November 10, 2025

Re: VARIANCE REQUEST CHARLES BREWER & CAITLIN HANNON PROPERTY 200 GLEN OBAN DRIVE ARNOLD, MD 21012

# OFFICE OF PLANNING AND ZONING

PROP. CONDITIONS SITE PLAN

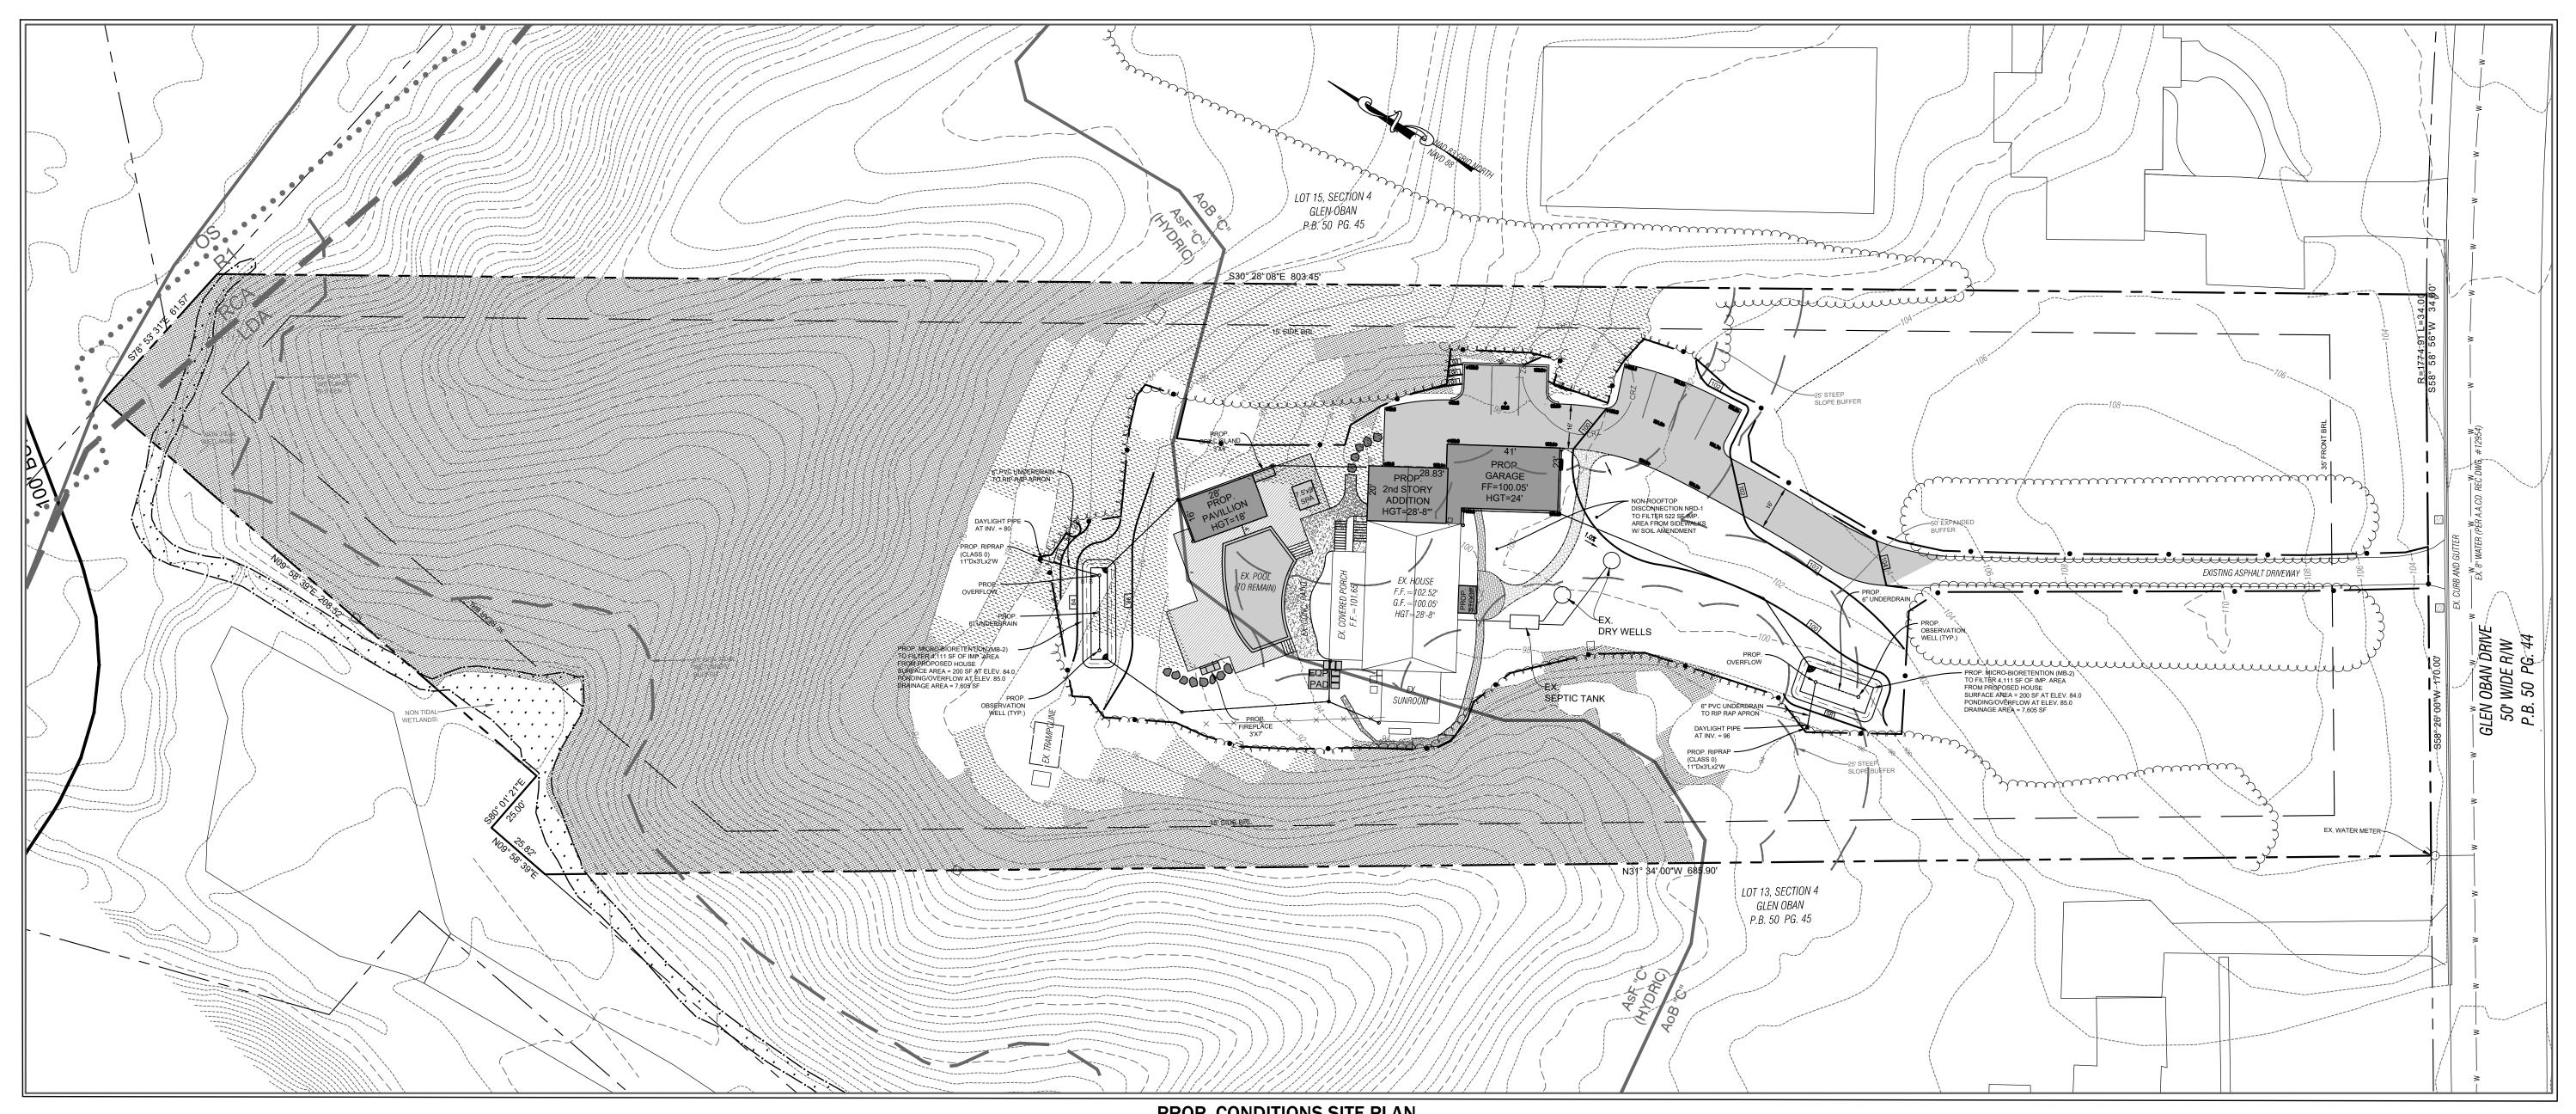
- 1. Show and label any existing and proposed stormwater management devices. Label what is to be done with any existing devices.
- 2. Show and label the existing water meter.
- 3. Add a legend for the various hatches and line types including the limits of disturbance, the three different fence line types, the walkway from the driveway to the proposed stoop, and the rock structure located west of the existing pool.
- 4. Include the proposed stoop in the limits of disturbance.
- 5. The limits of disturbance appear excessive on the downhill side for the structures to be removed.
- 6. Label all septic drywells.
- 7. It appears the plan view shifts to the northwest between the existing and proposed conditions making the review more difficult, as the same items are not shown in each view.

Relief to repair/replace the existing improvements can be supported however additional steep slope disturbance to accommodate any expansion of any of the existing improvements cannot be supported.
